ADDENDUM NO. 1

Wayne High School Campus Improvements

Fort Wayne Community Schools (FWCS)

November 7, 2025

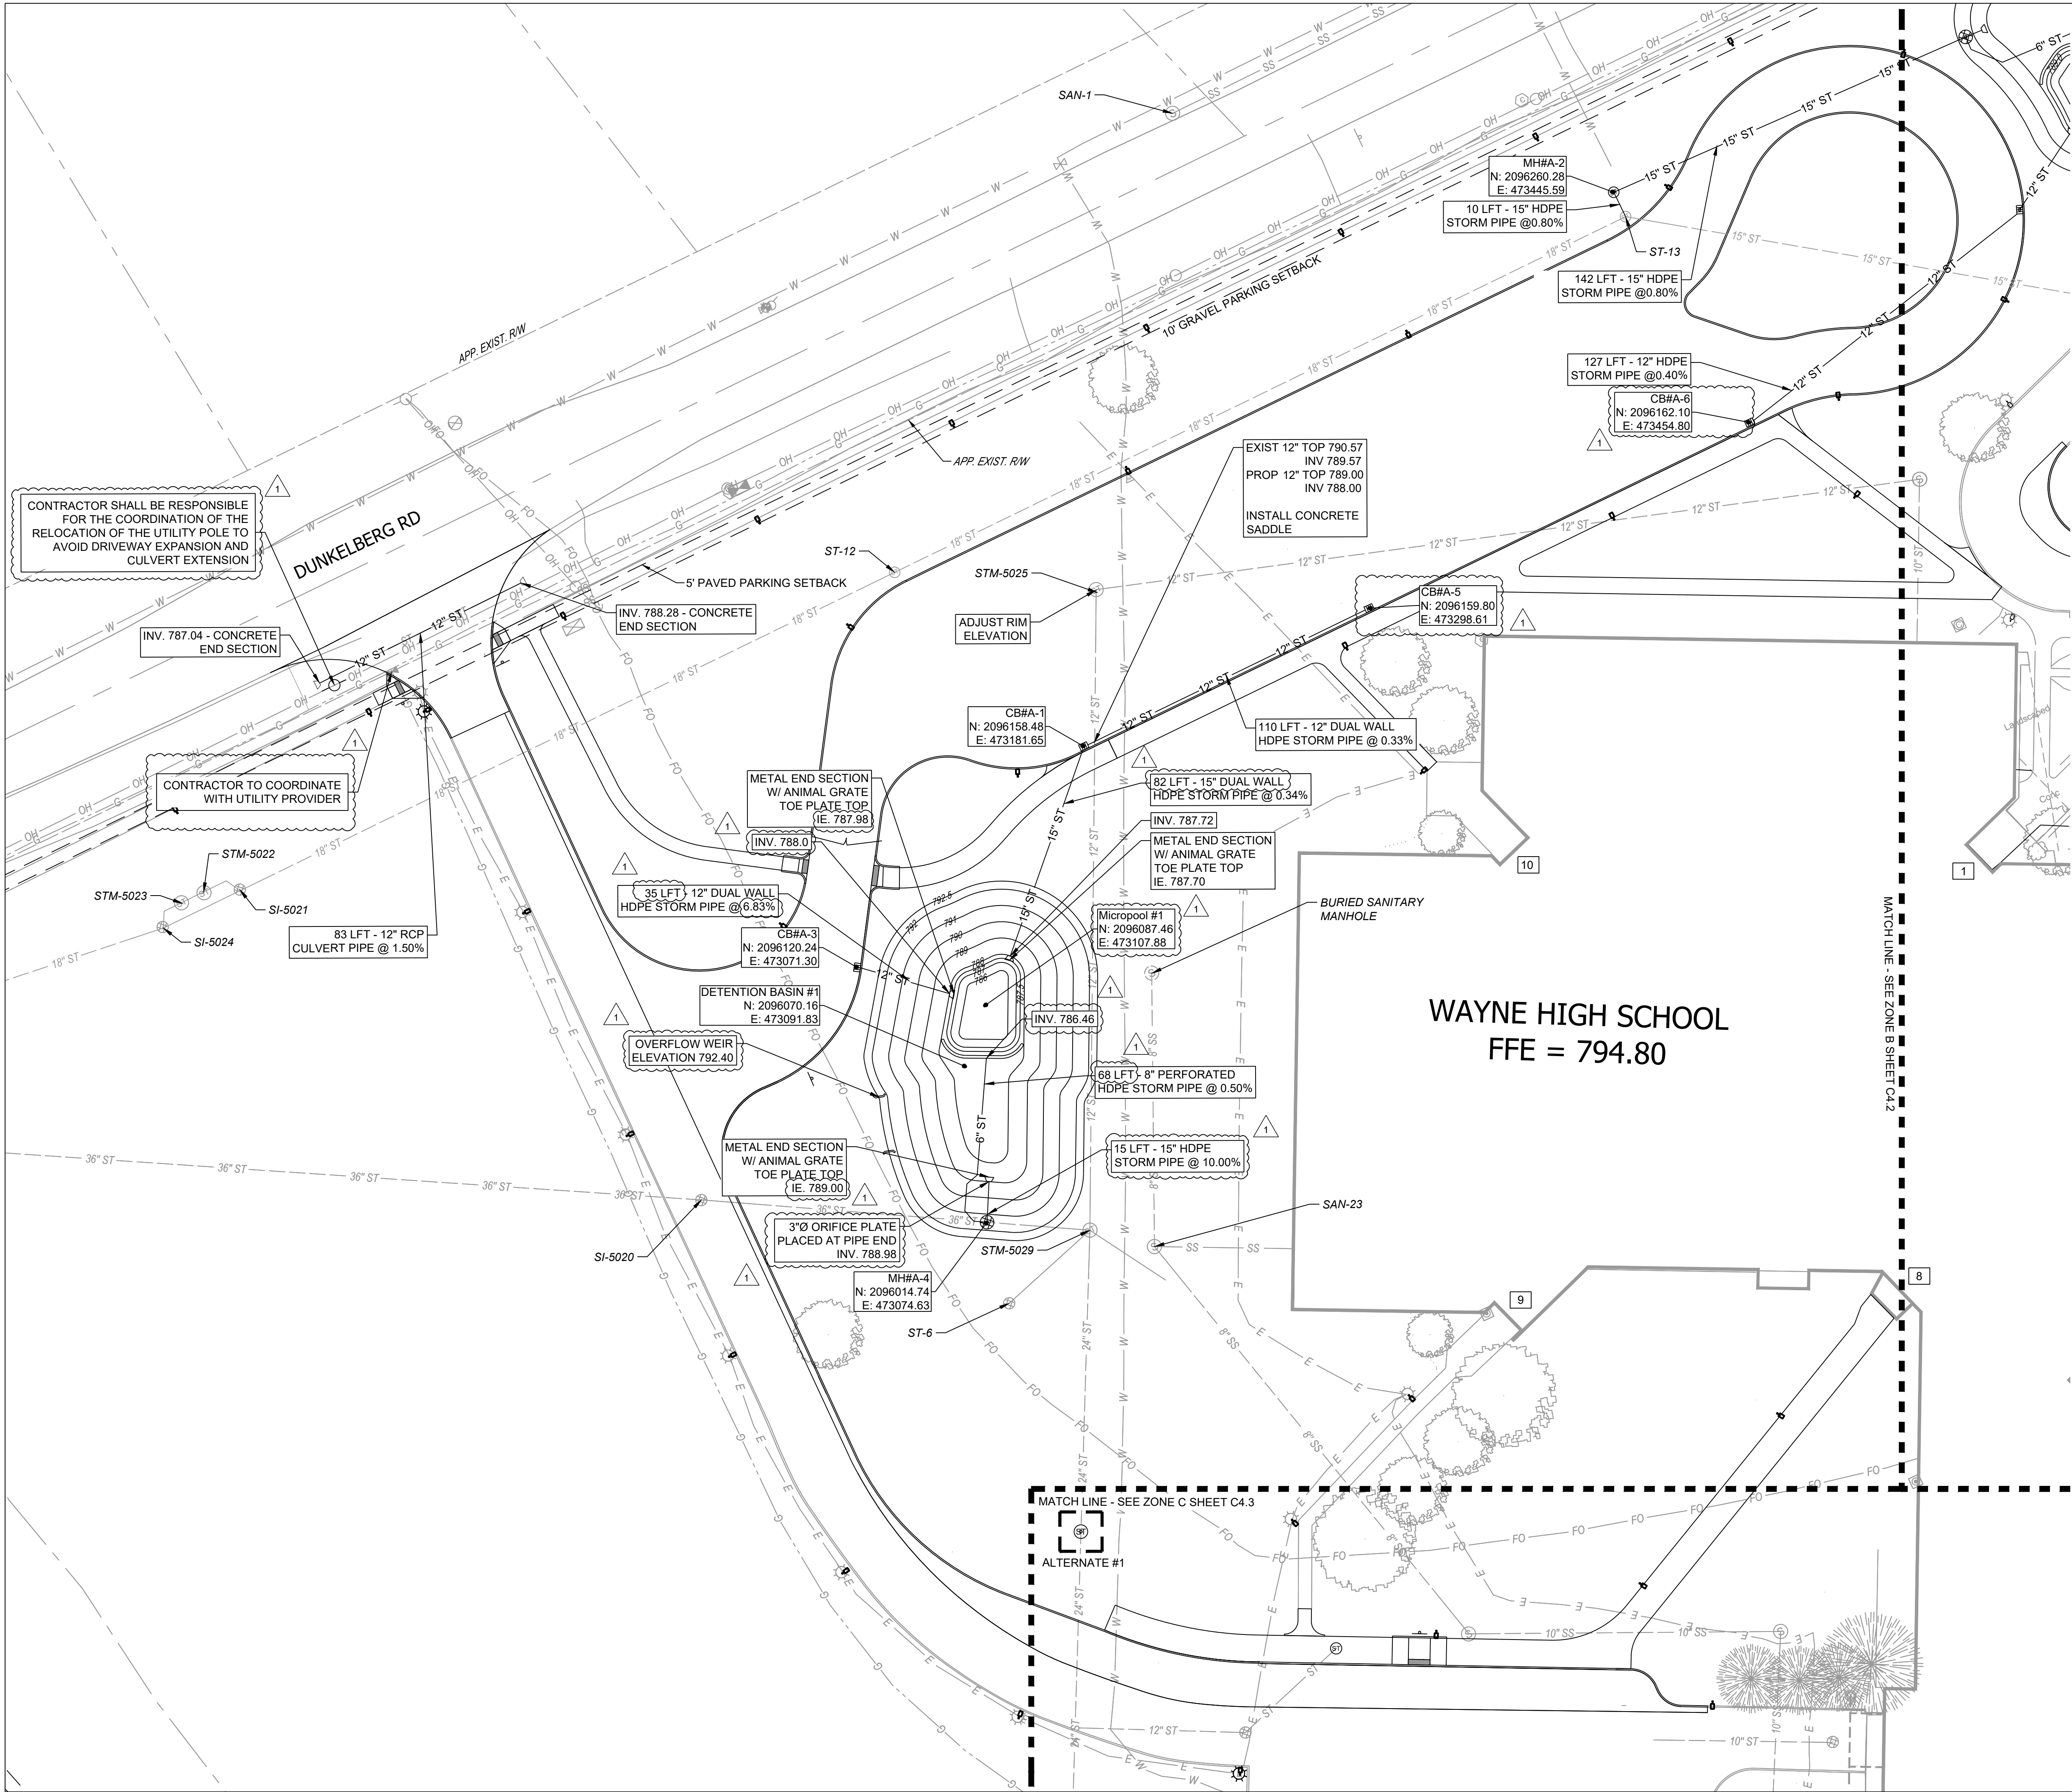
21. Plan Sheet C4.1 – Site Utility Plan – Zone A
REVISED: CB#A-5 and CB#A-6 Plan labels to include Northing and Easting.
REVISED: Outlet pipe size of CB#A-1 changed from 12" to 15".
REVISED: CB#A-5 structure elevation.
ADDED: Micropool to Detention Basin #1 to comply with Allen County Surveyor's Office stormwater comments.
REVISED: Detention Basin #1 size, inflow elevations per inclusion of micropool to comply with Allen County Surveyor's Office stormwater.
REVISED: Overflow Weir elevation from 792.50 to 792.40 per Allen County Surveyor's Office stormwater comments.
REVISED: MH#A-4 structure data table inverts and detail callout per changes in basin.
REVISED: Contractor notes on utility coordination.
ADDED: Proposed Lighting Improvement symbol to legend

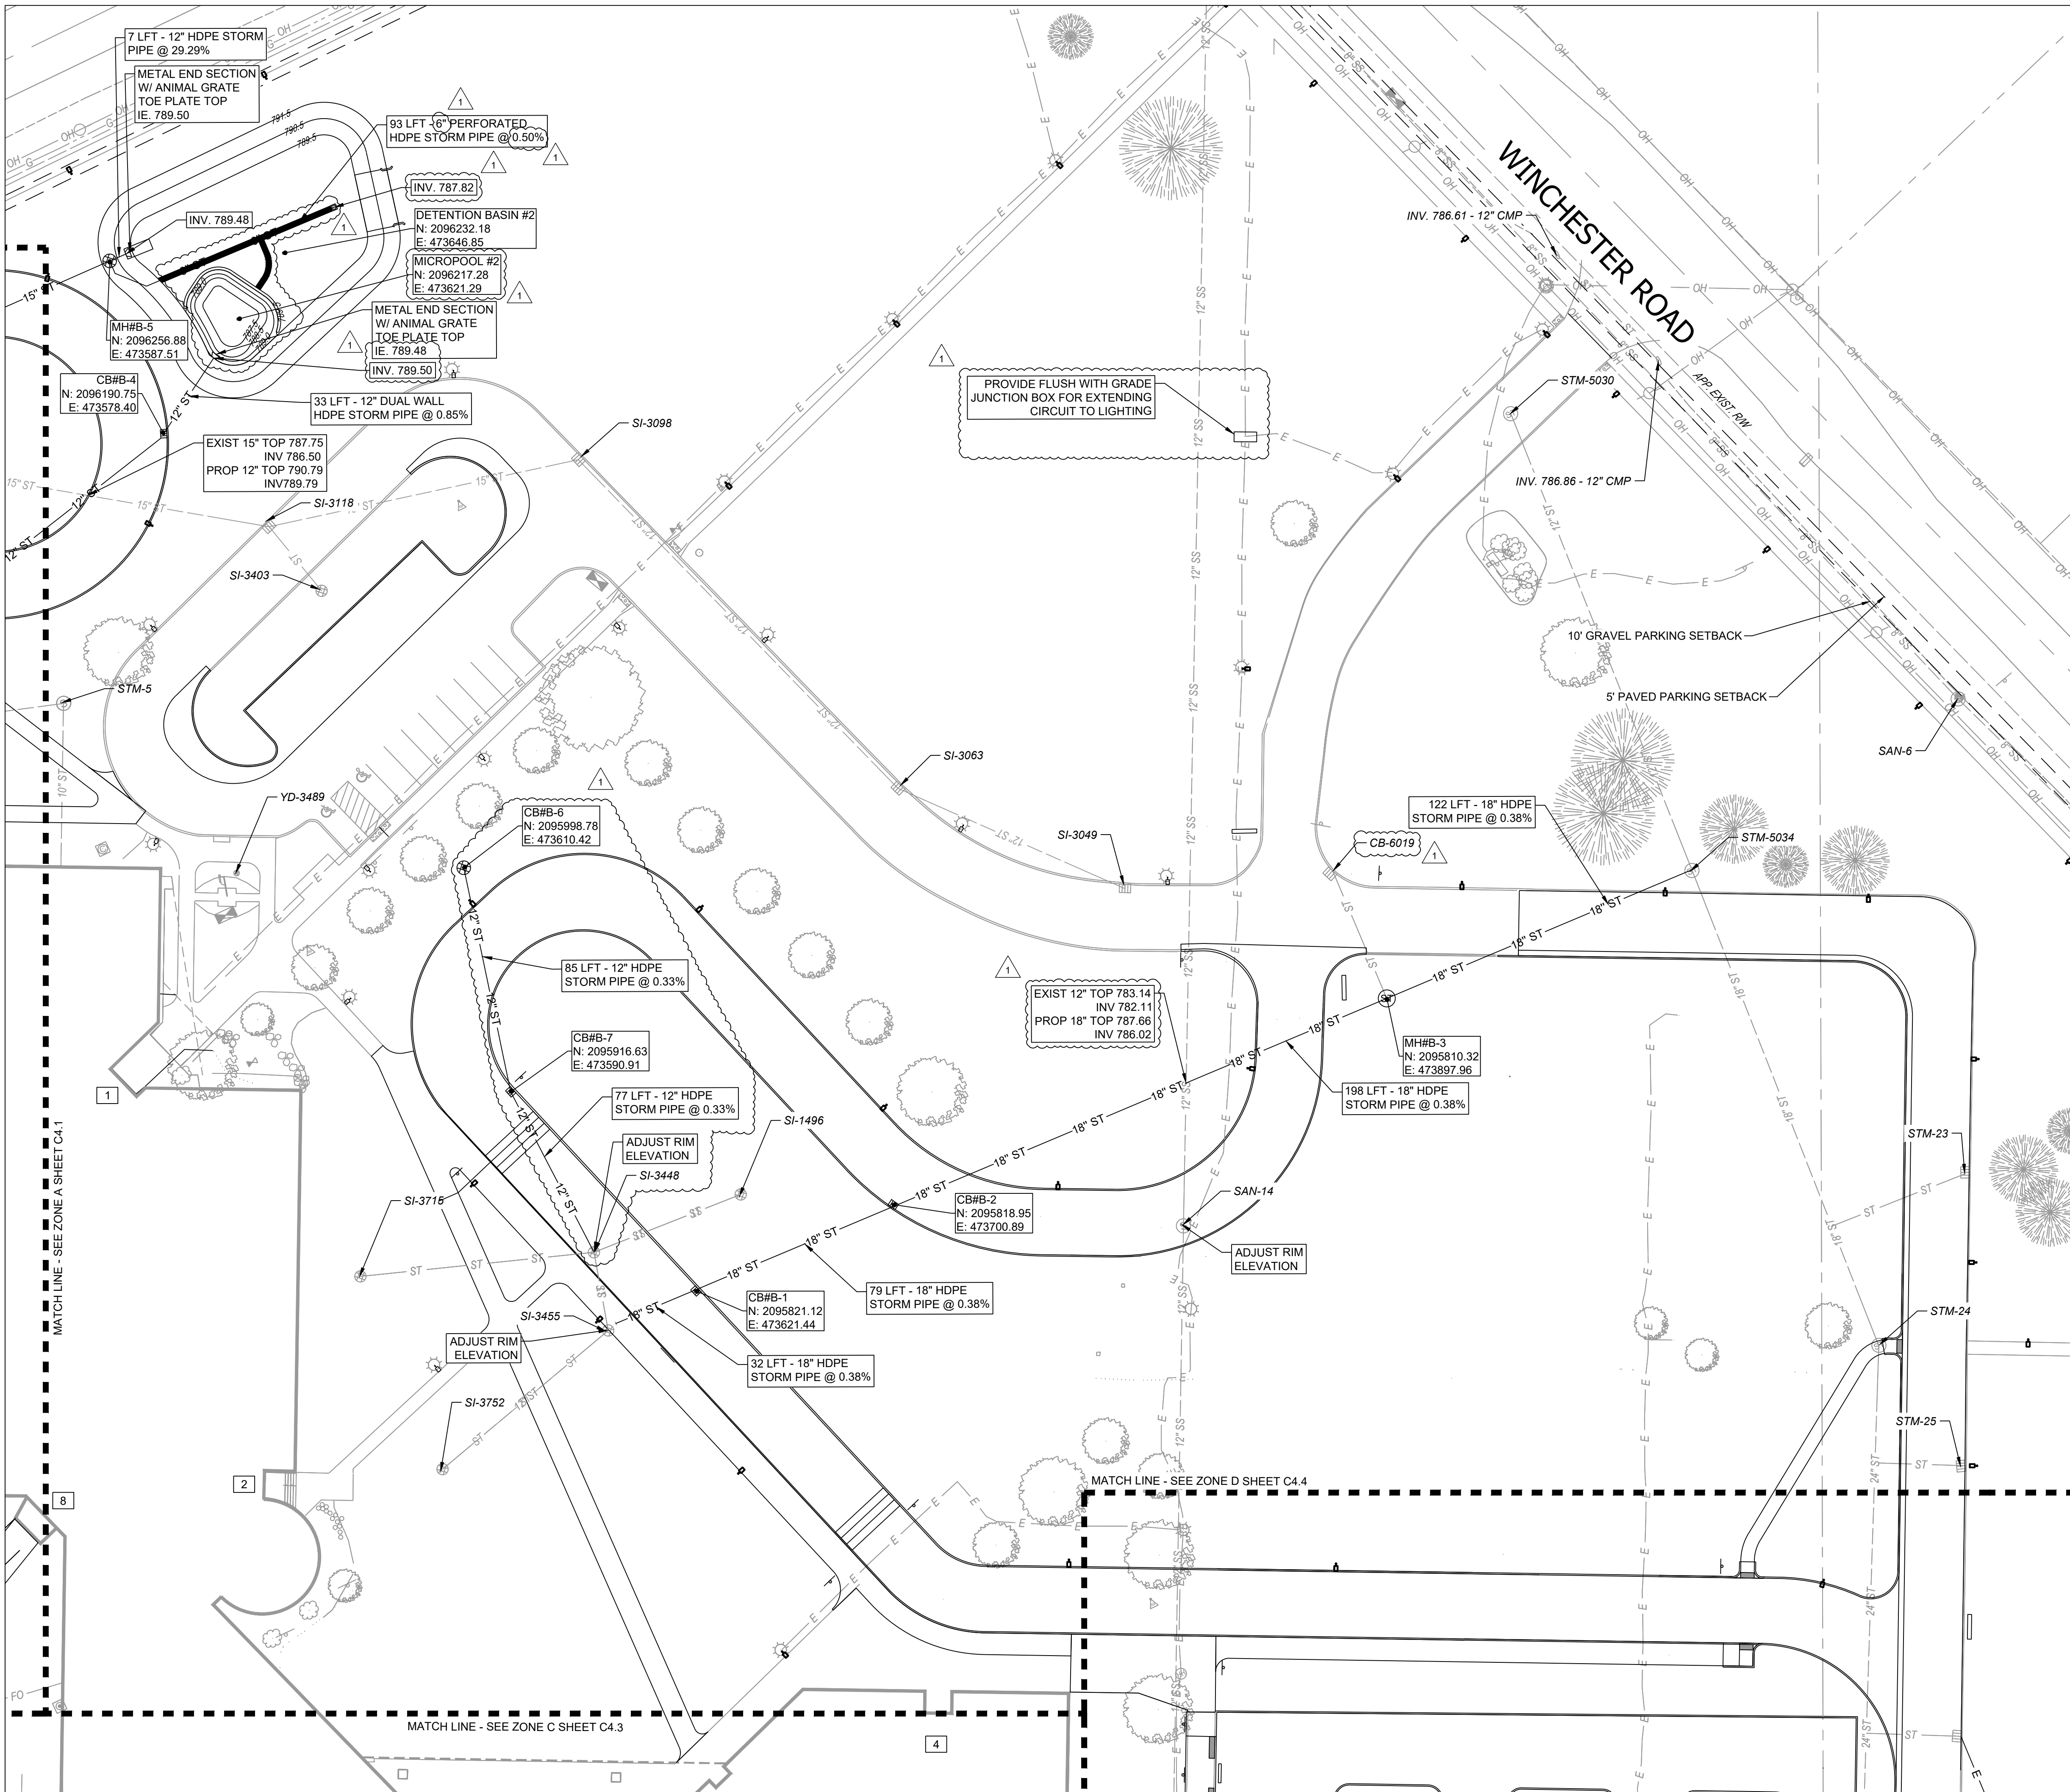
ADDED: Micropool to Detention Basin #2 to comply with Allen County Surveyor's Office stormwater comments.

REVISED: Perforated Pipe Size in Detention Basin #2 from 8" to 6" to meet Allen County infiltration trench detail. Lowered top of run invert to ensure one foot of cover per Allen County Surveyor's Office stormwater comments.

RELOCATED: Utility Crossing Notes onto plan.

ADDED: Proposed Lighting Improvement symbol to Legend.

ADDED: Junction box and callout to plan.

ADDED: Structures CB#B-6 and B-7 to plan and structure data table.

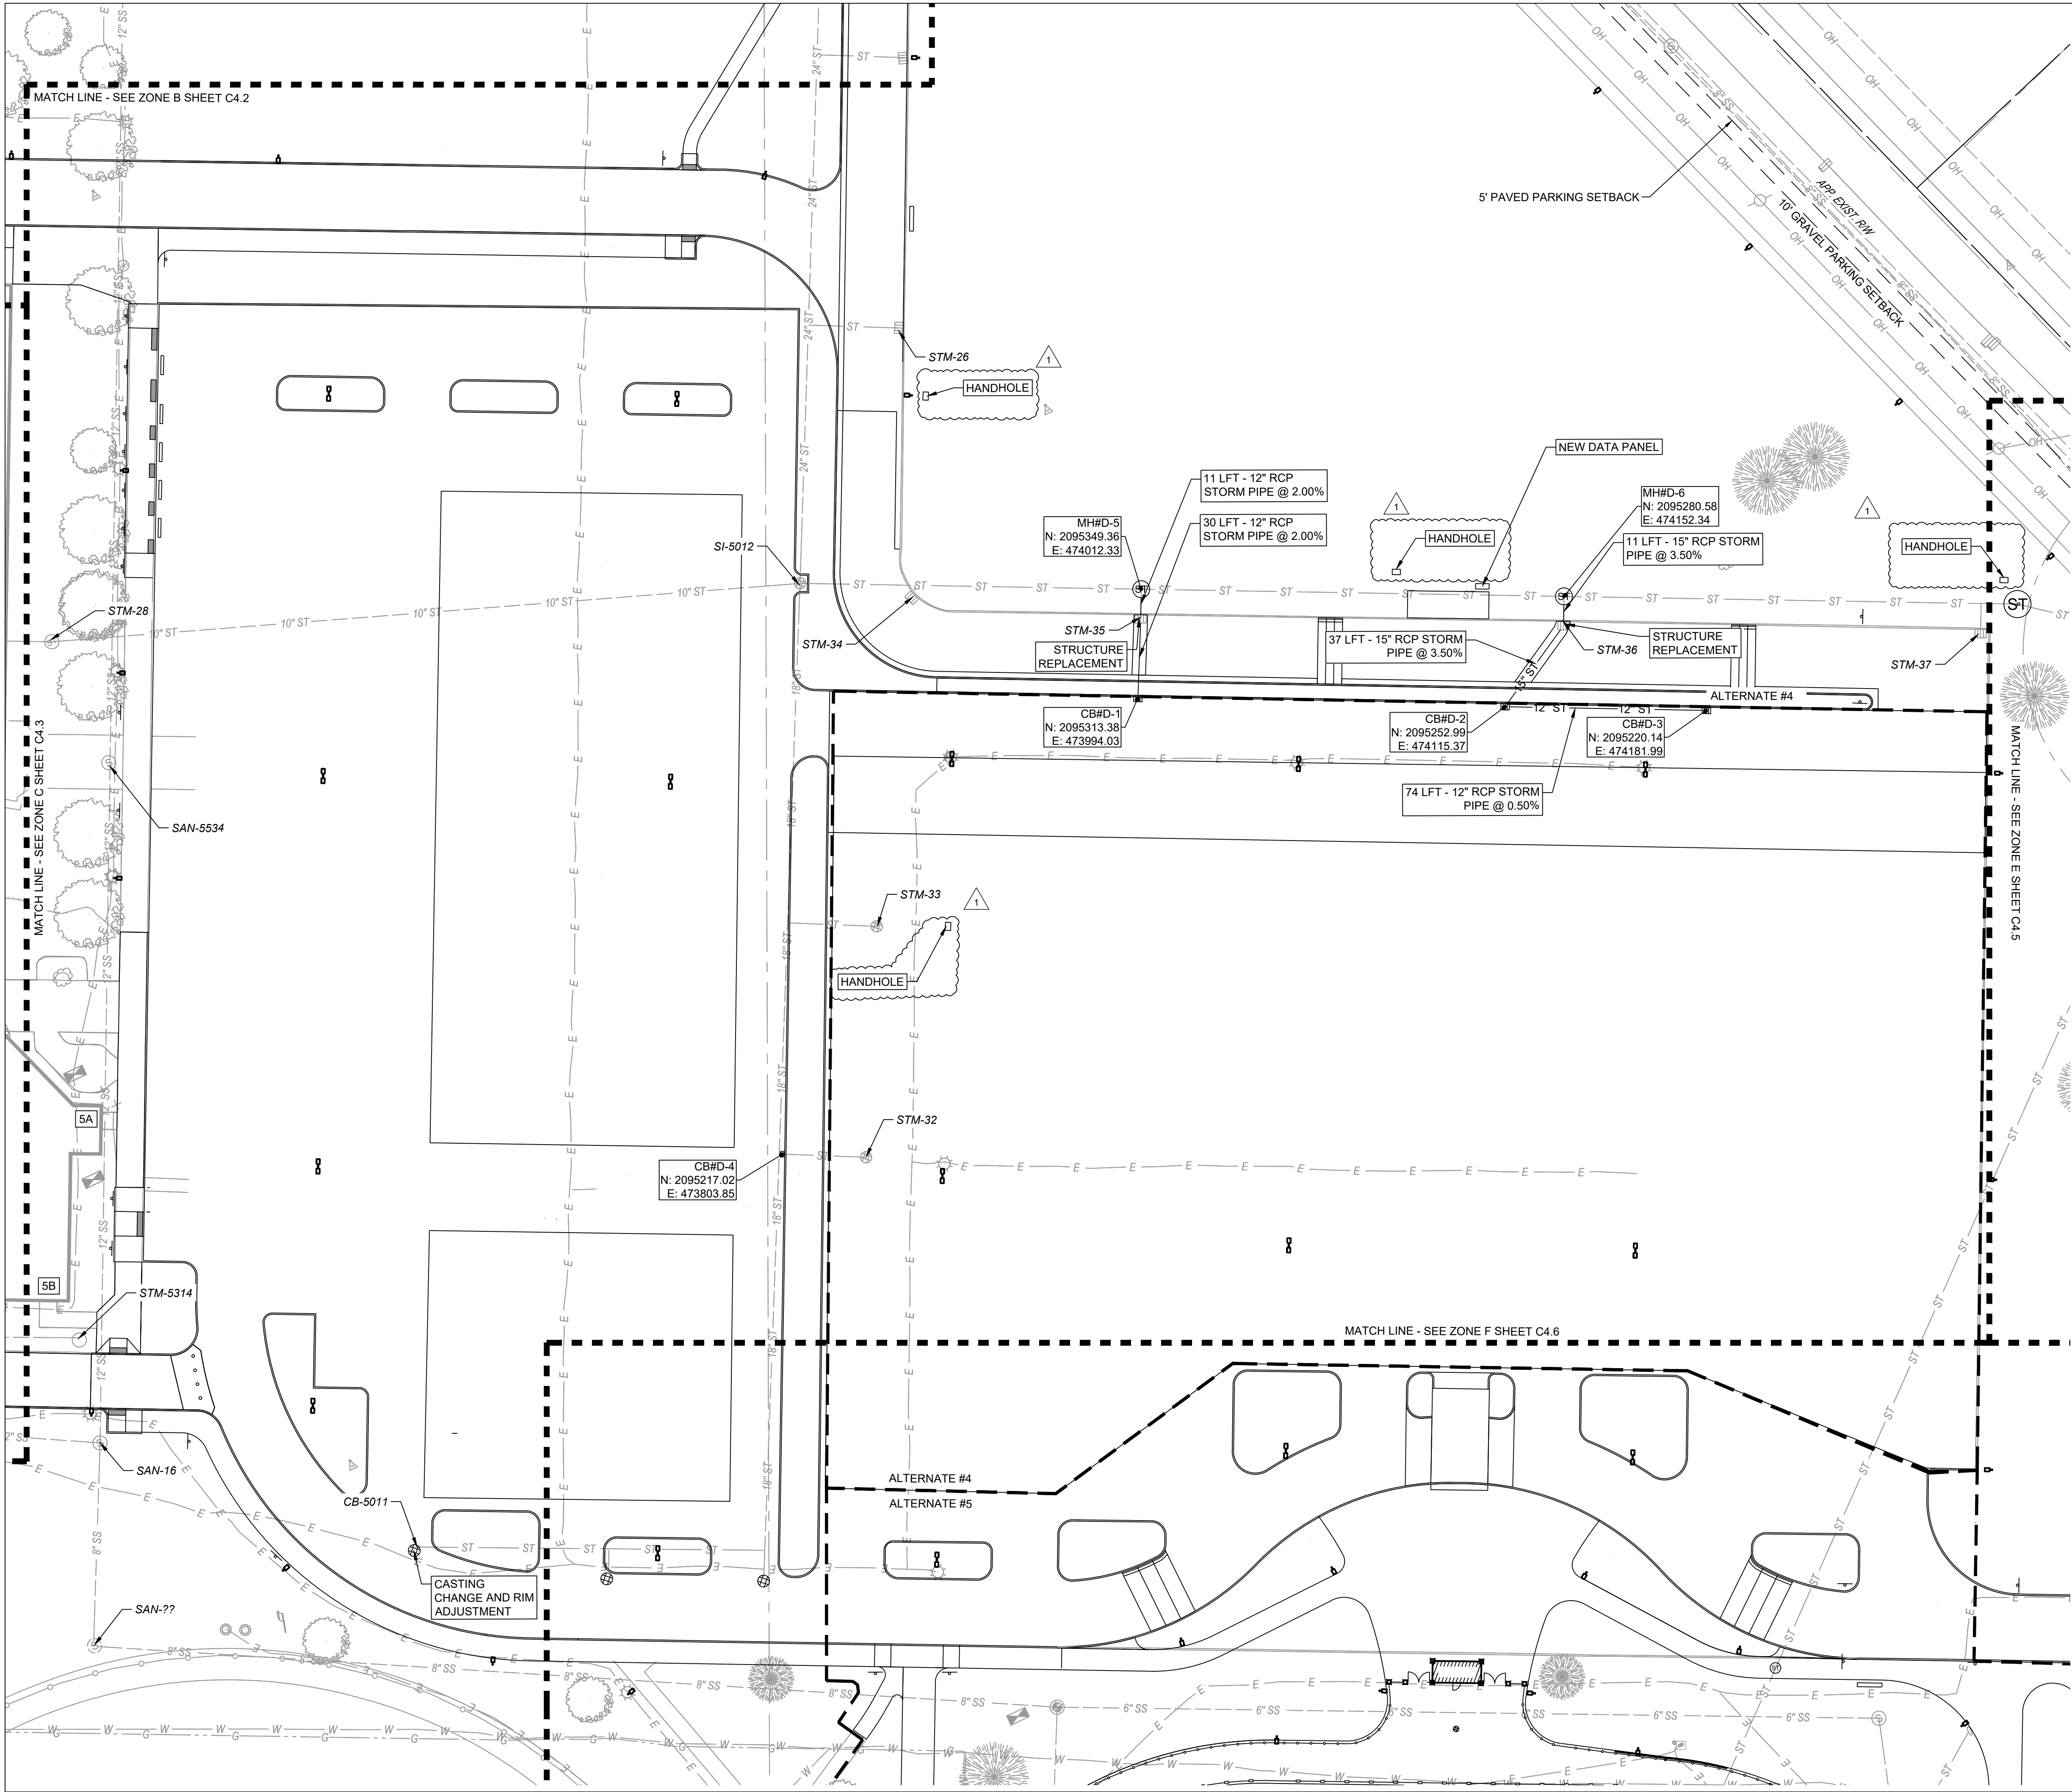
REVISED: MH#D-5 SW pipe material to “RCP” on Proposed Storm Structure Information Table.

ADDED: Surveillance camera callouts on plan.

ADDED: Proposed Lighting Improvement symbol to Legend.
